Revisions	Date
1 AMENDMENT #001	12/22/17

Drawing Title: CIVIL DETAILS - SITE IMPROVEMENT

Project Title: IMPROVE CAMPUS ACCESS AND SECURITY

Drawing Number: C-006

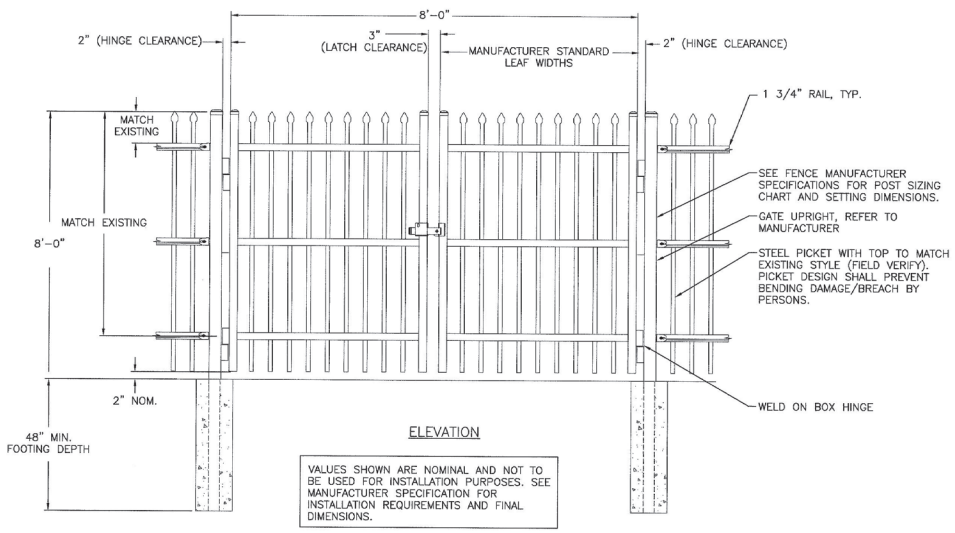
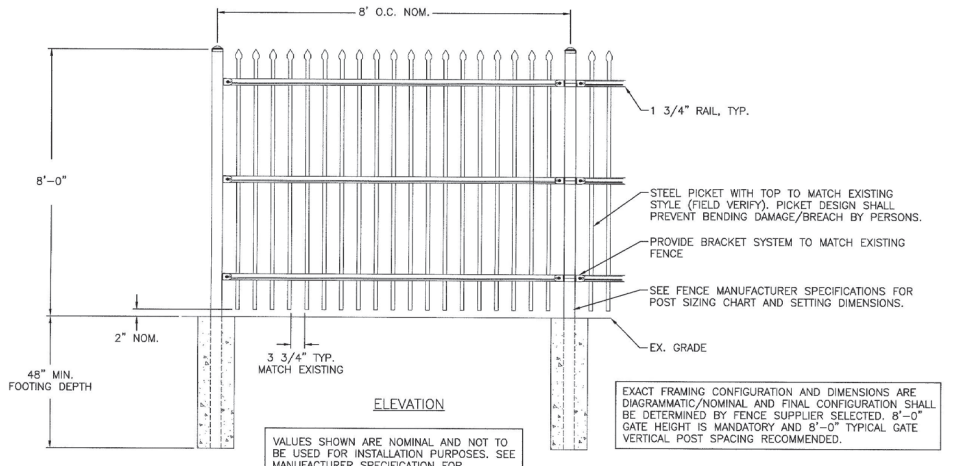
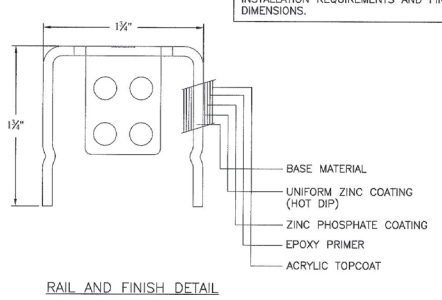
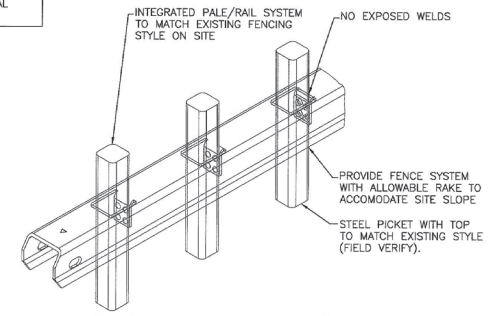
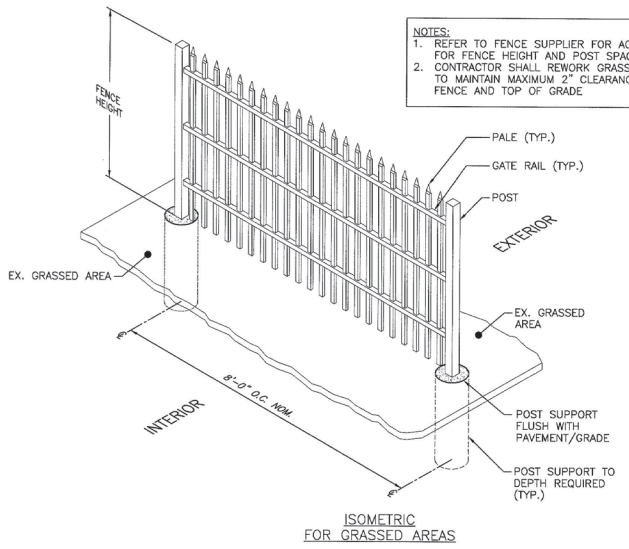
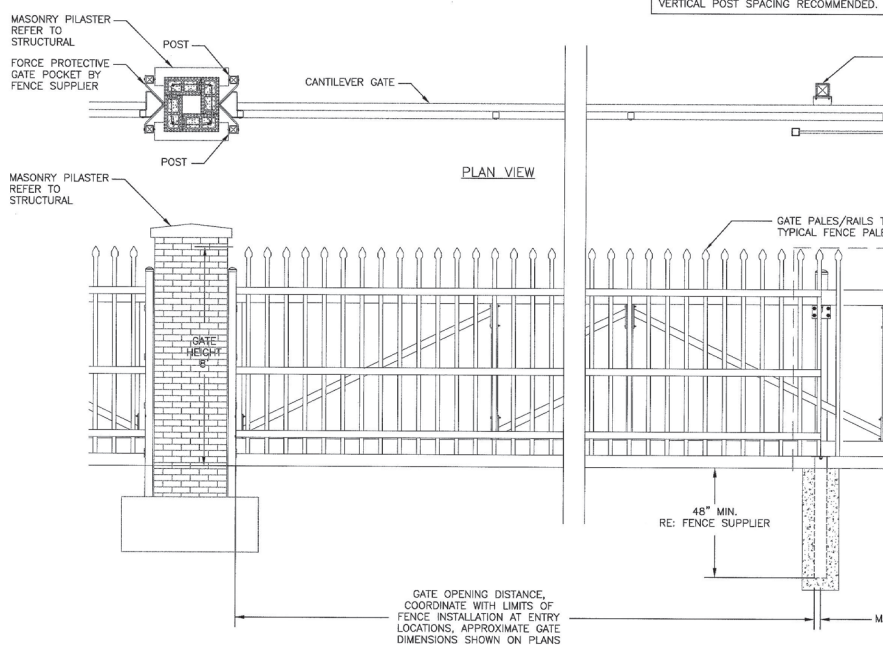
1 ENTIRE SHEET REVISED TO SHOW INTENT OF FENCING SYSTEM AND ADD CLARIFICATION, ADDITIONAL SECURITY ANTI-RAM INTEGRATION VARIES BY MANUFACTURER. MATCH EXISTING ORNAMENTAL FENCE FINISH AND PICKET TOP STYLE.
